# UNITED STATES PATENT AND TRADEMARK OFFICE

## Office Action Summary

10/563,176

ROYO, PAUL

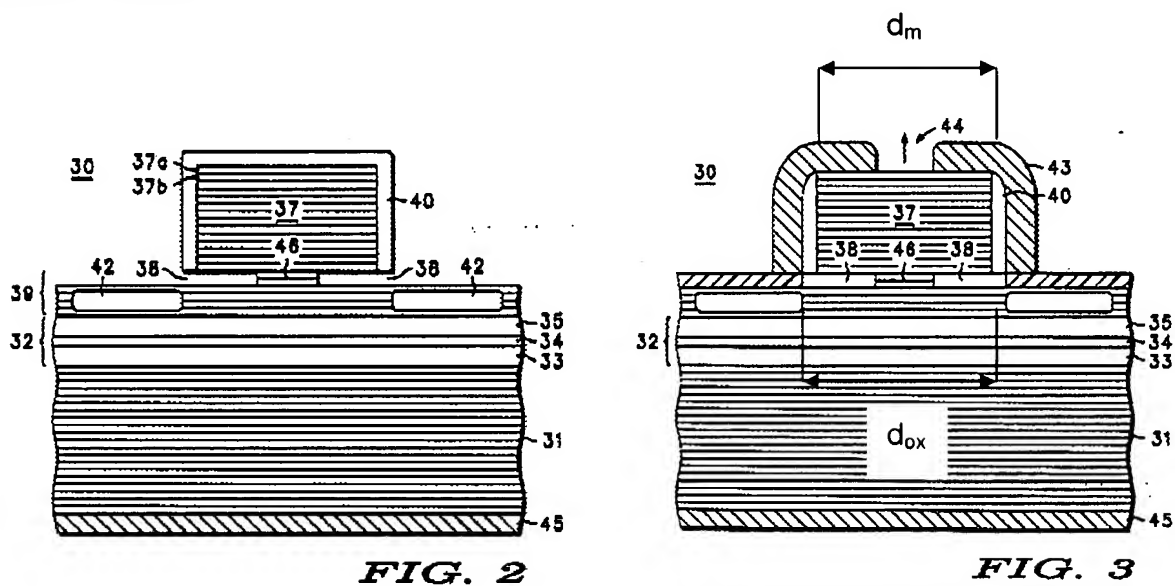
Regarding **claim 1**,

SHIEH et al. discloses in figure 2, 3 and specification:

a laser active region (32) , a resonator having a first reflector (31) and a second reflector (37),

the first reflector comprising

a first plurality of doped layers (31) having alternately a low index of refraction and a high index of refraction,

an aperture layer (42) located above said first plurality of doped layers (31) and formed of an insulating material that is substantially non-transparent for a specified wavelength range, the aperture layer having an aperture formed of conductive and optically transparent material with a first characteristic lateral size ( $d_{ox}$ ), and

a second plurality of doped layers (37) having alternately a low Index of refraction and a high Index of refraction (see, col. 3, lines 55-57), the second plurality having a second characteristic lateral size ( $d_m$ ), a difference of the first characteristic lateral size ( $d_{ox}$ ) (see, figure 2 and 3), and

the second characteristic lateral size ( $d_m$ ) being smaller than ( $d_{ox}$ ) (see, figure 2 and 3) and being adapted to generate increased optical losses of said resonator with respect to higher order modes for said specified wavelength range compared to the optical losses caused by said aperture layer alone, and

a radiation output window (44) formed above said first reflector or below said second reflector.
